Technical Service Bulletin

NUMBER: 24-01-00

Improved Driver Side Floor Duct

1999 - 2000 (WJ) Grand Cherokee

FIGURE 1

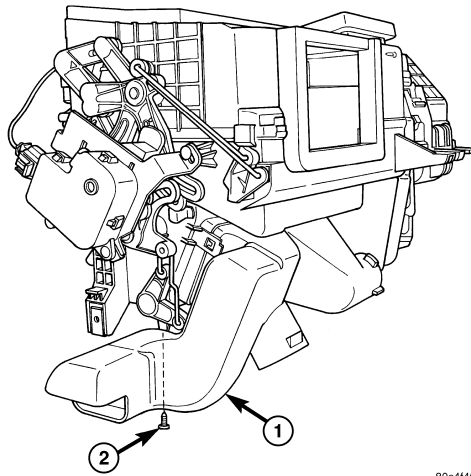
This bulletin involves replacing the drivers side floor duct

NOTE: THIS BULLETIN APPLIES TO VEHICLE BUILT BEFORE SEPTEMBER 1, 1999 (MDH 09 01 XX). VEHICLES BUILT AFTER THAT DATE CONTAIN THE REVISED FLOOR DUCT.

Customers may complain of cold driver's feet or inadequate airflow to the driver's side floor.

1. Locate the driver's side floor duct and attaching screw (See figure 1).
2. Remove the attaching screw and duct. This requires a very short #1 Phillips screw driver, approx. 1 1/2 inches in length.
3. Install the new duct, p/n 05012723AB, and install the attaching screw.
